<u>APPLICATION NO:</u>	24/00446/LBC	<u>CASE OFFICER:</u>	Maxine Wishart
<u>WARD:</u>	Halewood North	<u>PARISH:</u>	Halewood Town Council
<u>LOCATION:</u>	Foxhill House , Foxhill Lane, Halewood		
<u>PROPOSAL:</u>	ERECTION OF SINGLE STOREY REAR EXTENSION AND INTERNAL ALTERATIONS (DEMOLITION OF OUTRIGGER EXTENSION)

Removal in part of rear wall

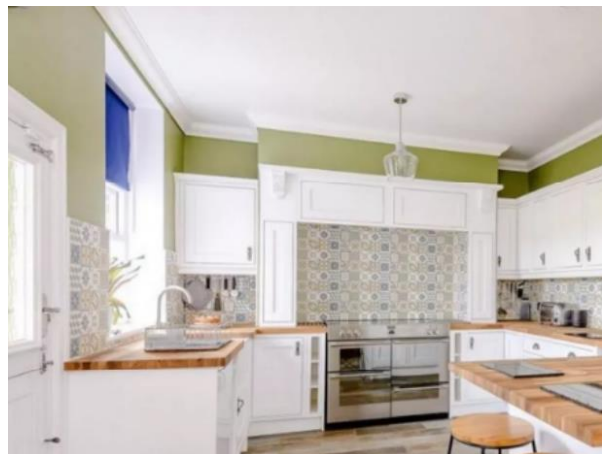
The removal of part of the rear elevation of the dwelling is proposed to enable the extension of the existing kitchen.

The Council's Conservation Officer has advised that internally; there is no objection to the proposed utility room. While there is no objection to the creation of the opening in the external wall to provide the open plan kitchen space, they have advised that wall nibs should be retained to each side of the opening in order to retain legibility of the original extent / plan form of the house. This amendment has not been forthcoming in the revised application detail.

The rear elevation is considered to be an integral part of the historic fabric of the building. The proposed removal of a section of this wall—without retaining nibs—and the loss of the chimney breast would result in the loss of historic fabric of the building to the detriment of the existing historic floor plan and internal features.
